SI B32 04 15 Steering and Wheel Alignment January 2016 Technical Service

SUBJECT Steering wheel rubs/brushes against the steering column trim

MODEL I01 (i3, i3REx)

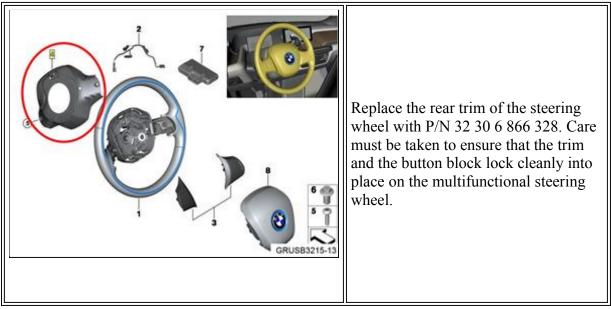
SITUATION

When the steering wheel is moved, it rubs/brushes against the steering column trim.

CAUSE

Rear steering wheel trim.

Part Number	Description	Quantity
32 30 6 866 328	Cover for steering wheel, rear	1
